# Applicant response to The Georgian Group consultee response dated 16/10/2025 from Dr. Thomas Whitfield

# Applicant response to Ross Anthony email dated 16/10/2025 from Historic Buildings and Places.

Applicant response to Conservation and Design officer response dated 30/9/2025

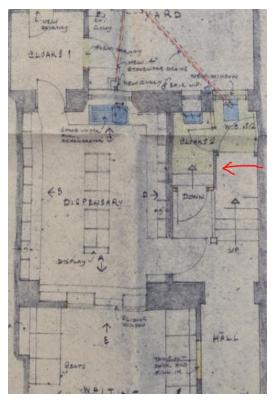
- Looking at photo from ground floor stairs, it looks to me as though the wall above panelling has been added when the door across the lower rear hall was added, suggesting 1965.

- Panelling is likely original as the 1965 scheme door is across is.
- Timber panelling likely original and should be retained; boarded area above dado height, which backs onto ground-first floor staircase balusters, 1960s addition.

# **Applicant Response:**

Architect drawing 2a which was submitted for planning approval shows this area as solid. I believe the area below the stair spindles is original and will be retained. The tan partition ply is from 1965 and installed at the same time as the door and door frame to create the WC. It is only these elements we seek to remove.

## **Applicant Response:** Agreed

Photograph of plan 2a detailing front elevation design from 1965

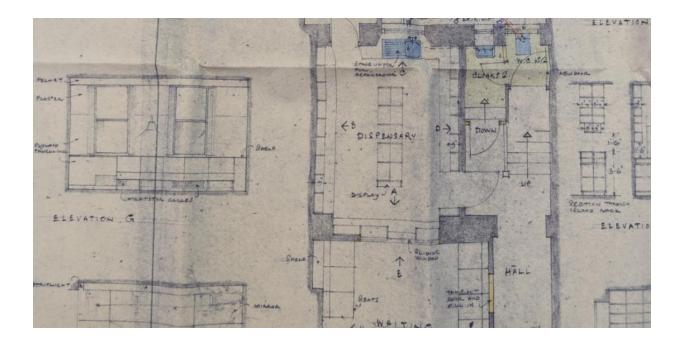
- Panelling formerly existed in window reveals at first and second floor level; full wall was panelled at ground floor level.
- From photos of this panelling before removal, I believe it was all original to the building, highly significant and in repairable condition.

- I object to its removal, which has caused substantial harm to the building.
- As the removal has already taken place, I am not able to inspect it to confirm its condition or repairability. From the photos, it appears that there was some cracking, and that the leaking gutter had caused some localised damage. However, I believe it very likely that most of the panelling could have been saved and appropriate repairs carried out, and that at least several and perhaps all of the sets of shutters and panelling to the upper floor windows could have been saved.

- Replacement of irreparable sections in like fashion.
  - Reinstallation and repainting.
- I note that the 1965 drawings for conversion into a pharmacist's dispensary have internal elevation drawings that show "plywood panelling" to the ground floor front room, which was a waiting room. However, from the photos I have prior to its removal, as well as a photo of some of the panelling after removal, I do believe it to have been the original panelling.

From submitted drawing 2a (approved), the front elevation is substantially changed. Whereas the original panelling between waiting room and corridor was covered by studwork and plasterboard after closing off the original door and removing panelling to form the new waiting room entrance, no such arrangement is detailed for the front elevation window panelling. If it was, it is not clear. With lino floor coverings, bricking up the fireplace, installation of electrical storage heaters etc, it would seem the design ethos was that toward the prevailing tastes of the 1960's and not preservation.

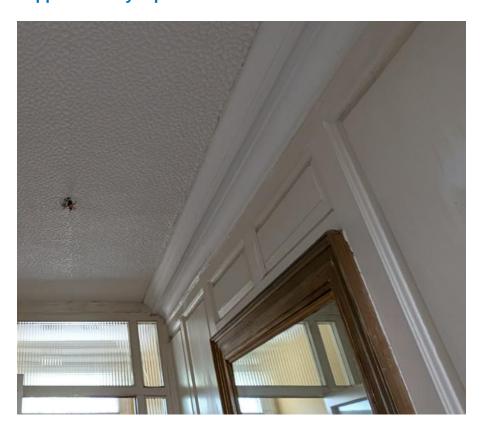
- This is difficult to comment on as cornicing has already been removed in the ground floor front room (as has the lath and plaster ceiling, which also shouldn't have happened) so it is not possible to say what condition it was in and whether it could have been saved.

- This is not supported in a general sense, although the outcome is the same: the cornicing to the ground floor front room should be reinstated in the same dimension and profile as it was.
- Is any of this cornicing retained, which could be copied?
- What are the locations in the house where cornicing was removed?
- · Removal of skirting boards.
- Same comments apply as for cornicing above.

## **Applicant Response:**

The only cornicing removed has been from the front ground floor room. It was not original. The skirting boards were also not original. Evidence below:

Cornicing and picture rail as present in front ground floor room 2024. Note the lack of paint layers allowing fine contour definition. Applicant believes replaced circa late 1990's, early 2000's as it fits the enlarged stud work around the chimney breast formed in 1965. Pre-1965 would not be long enough to encapsulate the studded chimney breast.

Believed to be original style cornicing in corridor and as such, applicant would prefer to follow replacement with this design. It is logical that this cornicing would remain original if the panel it sits on is also original and the corridor itself has not changed width. Cornicing is absent from all rooms except the corridor, kitchen and rear 1<sup>st</sup> floor bedroom. All are non-matching.

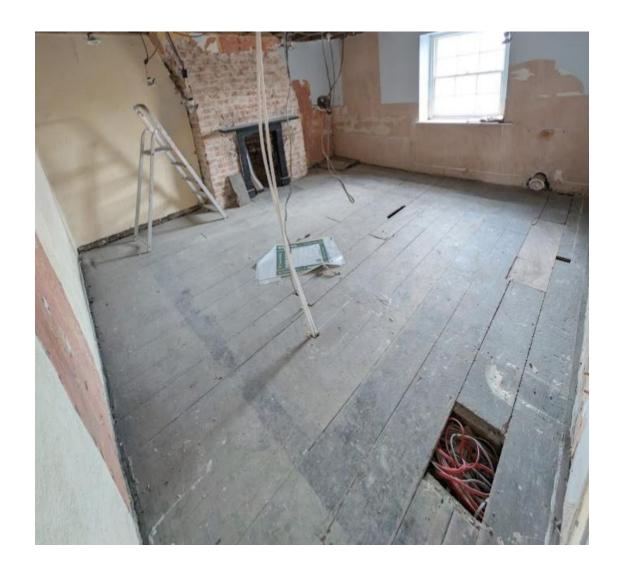
- Remove floor boards from 2nd floor bathroom and use to repair other floors through the house.
- There is some harm in this, as the boards are large and historic, and their relocation would require at least partly cutting them up. I would view this as less-than-substantial.

- I would be grateful for more information about the specific areas where new floorboards are required, the total surface area of those areas, the surface area of the bathroom, and any information about what will be done with surplus material.

Applicant Response: The first floor froont room only requires minor attention. There are two small areas where original board is missing and pine ceiling type board has been inserted. These are 310x290 and 150x90. Both are in areas that might largely be covered by a bed and bedside table. It is not crucial that these are addressed.
